Access Compliance Report Public Rights-of-Way (Curb Ramps)

Main Street: ANDAZA_ST Cross Street: N/A Location: SW

ADA ID: RPRK211203122901 Ramp Type: Type 4 - Parallel Initial Pass/Fail: Fail Overall Compliance: No Severity Score: 2

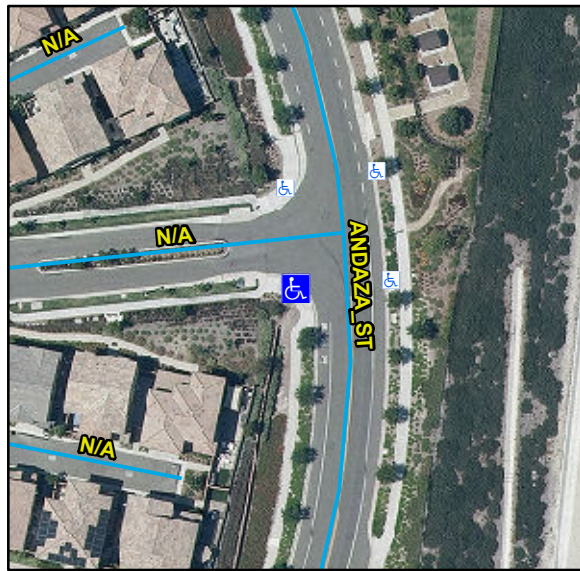
Compliance	Description	Data	Compliance	Description	Data
N/A	Ramp Length LT (in)	101	N/A	Ramp Length RT (in)	108
Yes	Ramp Width LT (in)	89	Yes	Ramp Width RT (in)	89
Yes	Ramp Run Slope LT (%)	5.6	Yes	Ramp Run Slope RT (%)	7.8
Yes	Ramp Cross Slope LT (%)	0.7	No	Ramp Cross Slope RT (%)	4.3
N/A	Landing Present	N/A	N/A	DWS Provided	N/A
N/A	Landing Length (in)	N/A	N/A	DWS Contrast	N/A
N/A	Landing Width (in)	N/A	N/A	DWS Length (in)	N/A
N/A	Landing Run Slope (%)	N/A	N/A	DWS Full Width	N/A
N/A	Landing Cross Slope (%)	N/A		DWS Offset Type	N/A
N/A	Landing Movement Obstructed?	N/A	N/A	DWS Offset Left (in)	N/A
	Landing Movement Type	N/A	N/A	DWS Offset Right (in)	N/A
N/A	Landing Shared	N/A			
N/A	Clear Space	Yes			
N/A	Clear Space To Crosswalk (in)	N/A			
N/A	Marked Crosswalk 1	No	N/A	Marked Crosswalk 2	No
	Crossing 1 Direction	E		Crossing 2 Direction	N
	Marked Crosswalk 1 Width (in)	N/A		Marked Crosswalk 2 Width (in)	N/A

Remove & Replace Curb Ramp With Two New Directional Ramps or Equivalent.
